Core Bus Corridor 13: Bray

16th December 2020

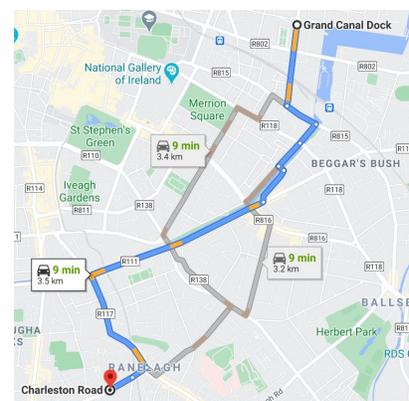
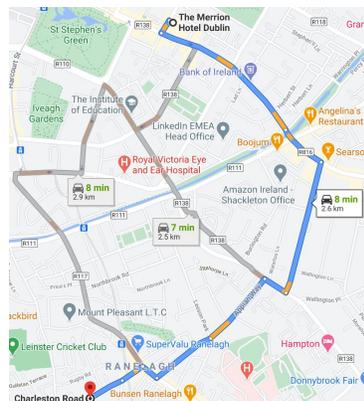
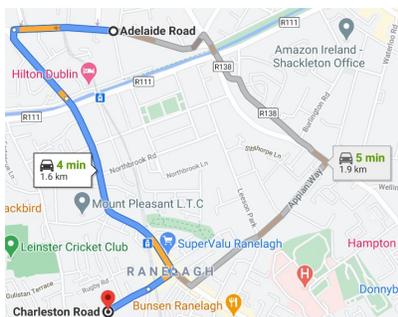
Map 5 - On Sussex Road, the 120 m stretch of unprotected cycle lane sandwiched between moving traffic and parked taxis/coaches is extremely unsafe. The cycle path

should be on the other side of the parked vehicles, and the coach stop should be fully bypassed.
